Sheringham Shoal and Dudgeon Offshore Wind Farm Extension Projects

Final Statement of Common Ground with Natural
England (Offshore) (Revision B)

Document Reference: 14.7

Plate 1: Location (Light Blue Dots) of Evidence of Previous Native Oyster Beds within Cromer Shoal Chalk Beds (CSCB) MCZ

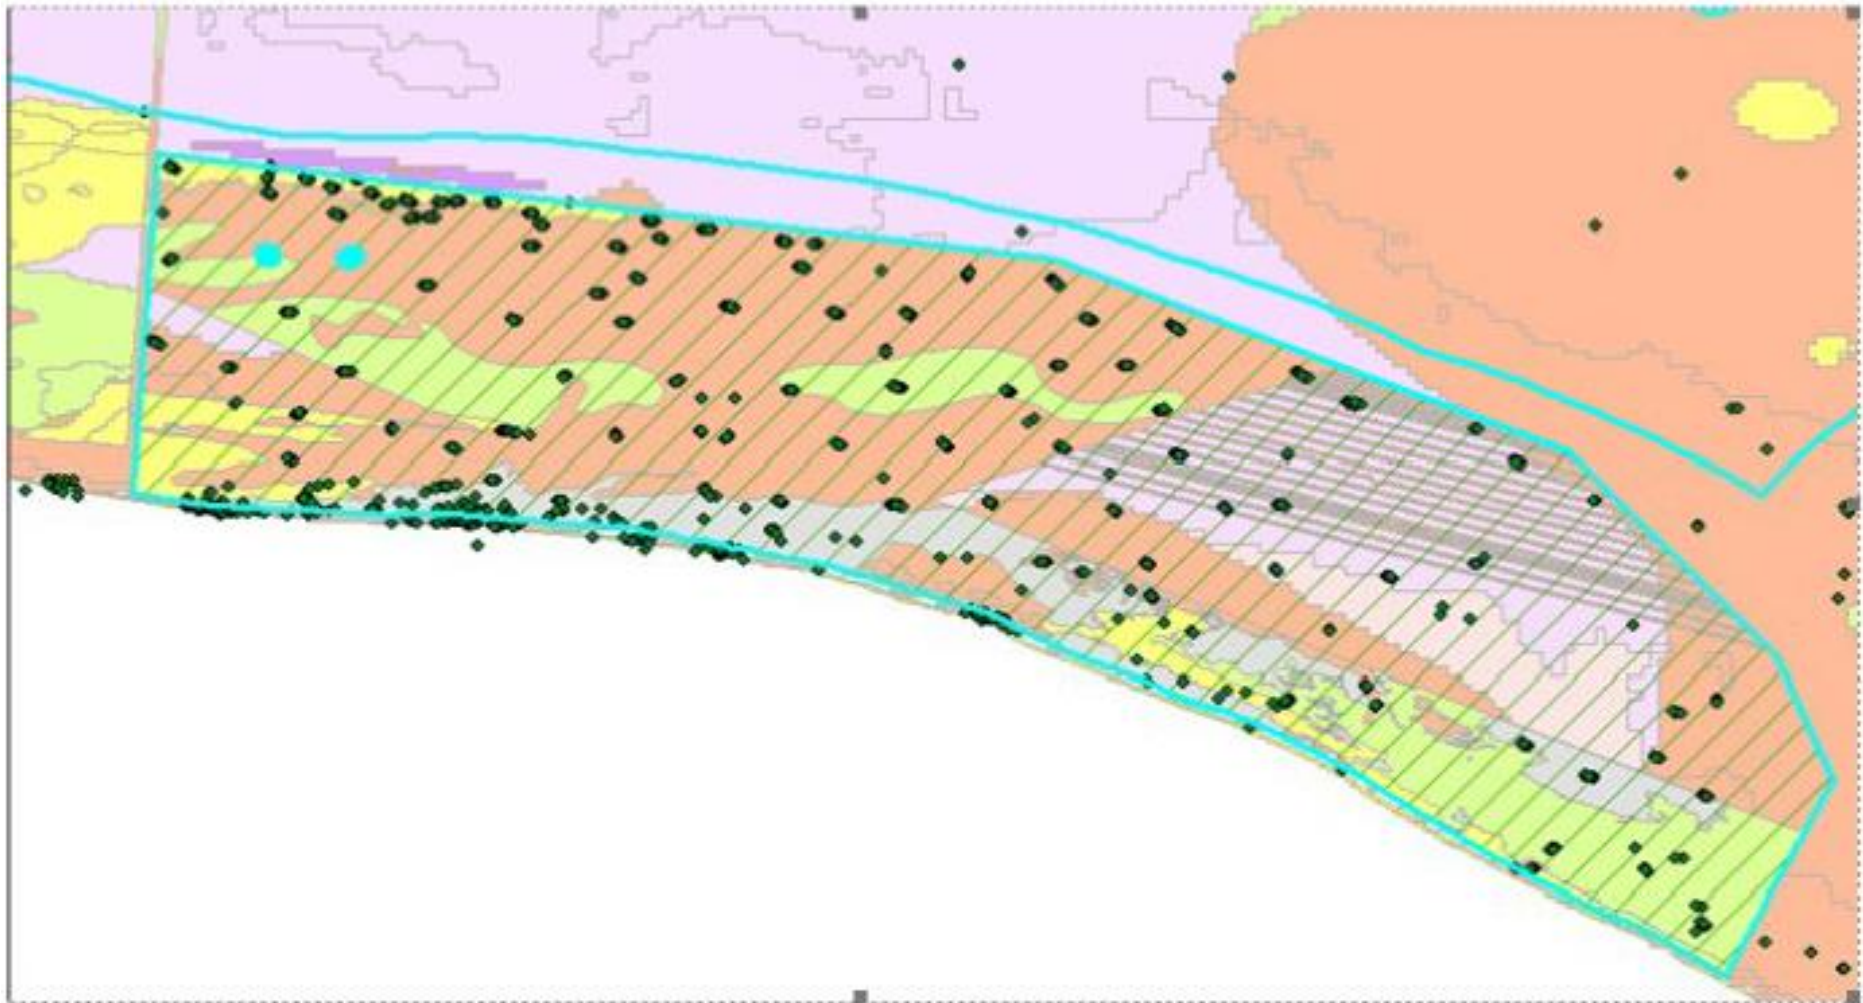
ID	Agreement	Natural England	MMO	Cefas	The Wildlife Trusts	EIFCA	Notes
7.5	Do you agree that the area of search for determining feasibility of oyster reef planting should focus on the areas identified in Plate 1 (see below) of Natural England's advice broadening out to the wider north western portion of the MCZ and focus on subtidal sediment features avoiding potentially sensitive habitats e.g. chalk, reef etc.?	Agreed	Defer to Natural England	N/A	Not present	Not agreed	<p><u>EIFCA</u></p> <p>Concerns raised that the 'previous oyster bed evidence' relates to historic fisheries shell deposit grounds. In this context, we don't agree that Plate 1 should be titled "...evidence of previous native oyster beds..".</p> <p>Any potential site should be selected based on current environmental factors that are most agreeable to support the success of the MEEB.</p> <p>An effective appraisal of all environmental factors, to gain an understanding as to why native oysters have not re-established naturally should be undertaken. It would also be beneficial to find out whether native oyster beds were present in the MCZ historically – although it could be difficult to find any evidence for this. It should not be assumed that fishing is the only cause of decline in oyster stocks and distribution, and all relevant environmental factors must be considered.</p> <p>As this is an MCZ social and economic factors should be considered when evaluating any intervention, even those for conservation benefits such as MEEB.</p>
